CITY LINK TRUCKING

Construction Drawings

PCD FILE NO. PPR2339

TITLE SHEET

HORIZ. SCALE:	N/A	DRAWN:	PV
VERT. SCALE:	N/A	DESIGNED:	JPS
SURVEYED:	LDC	CHECKED:	JPS
CREATED:	08/29/22	LAST MODIFIED:	02/14/24
PROJECT NO:	052301	MODIFIED BY:	PV
SHEET:	C3.1

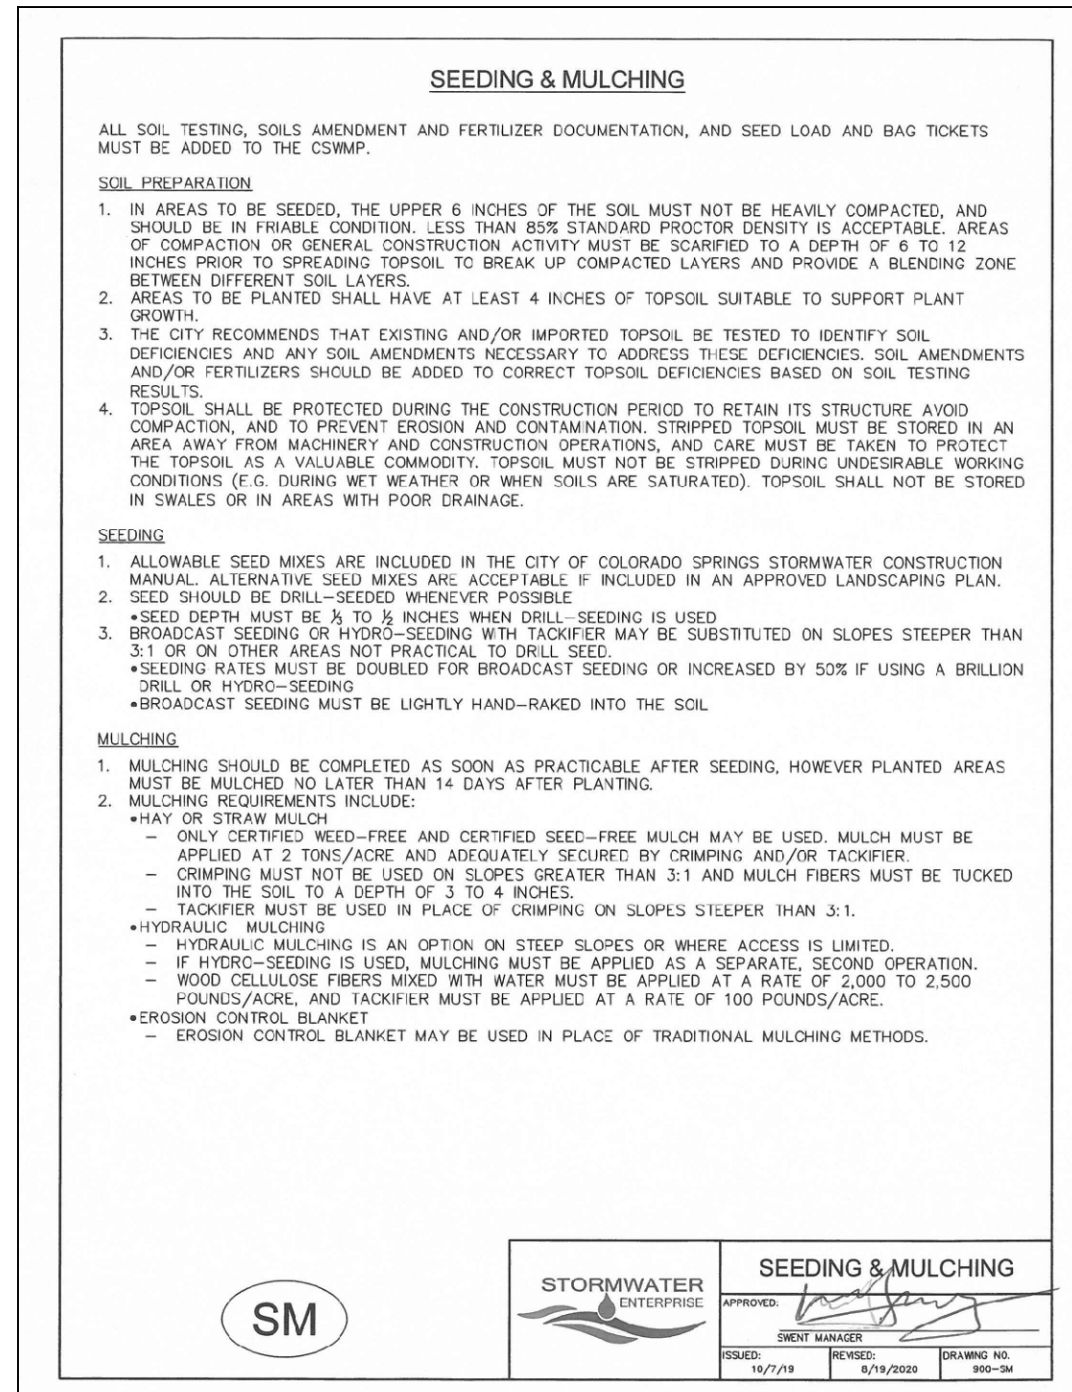
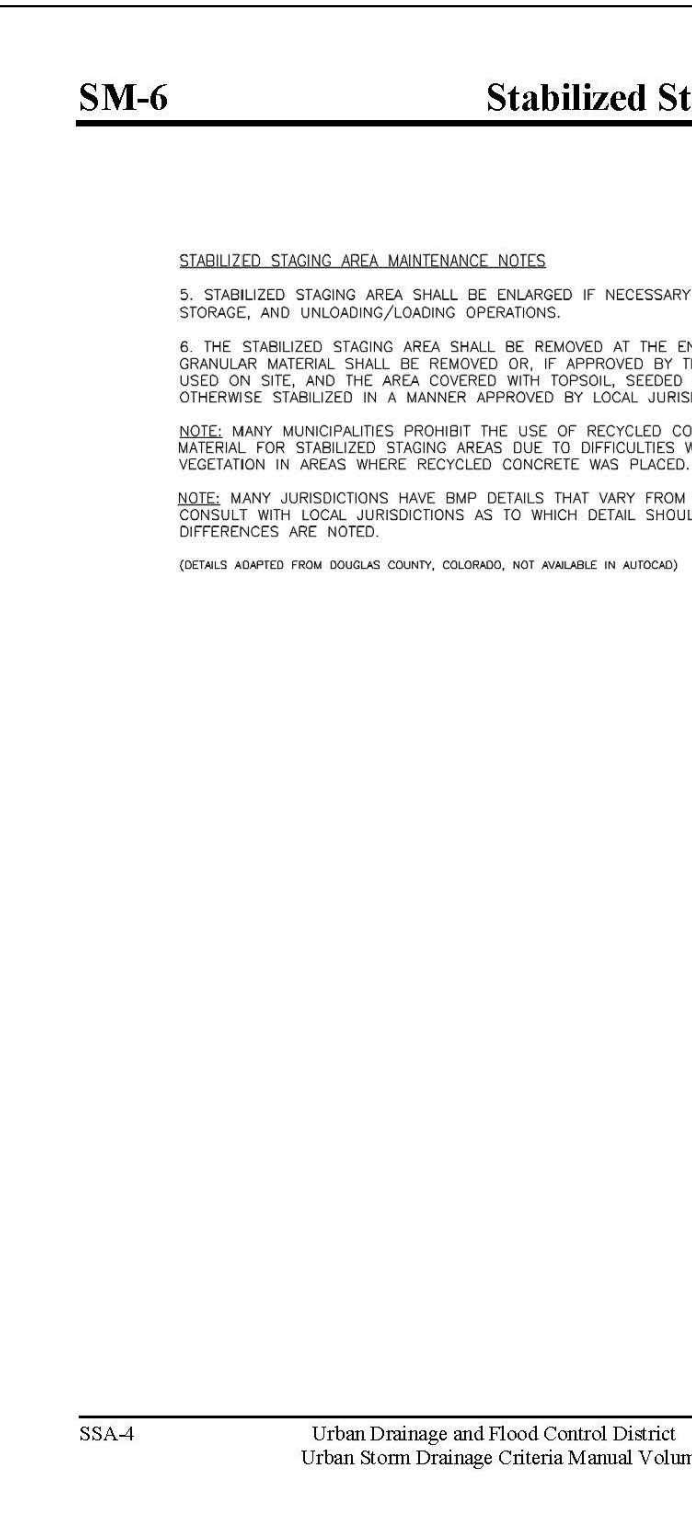
This is not a full detail for the TSB. Verify if this is an old detail. The current TSB detail on the Cities website shows grading and other details as well as providing tables. Up to date details should be used.
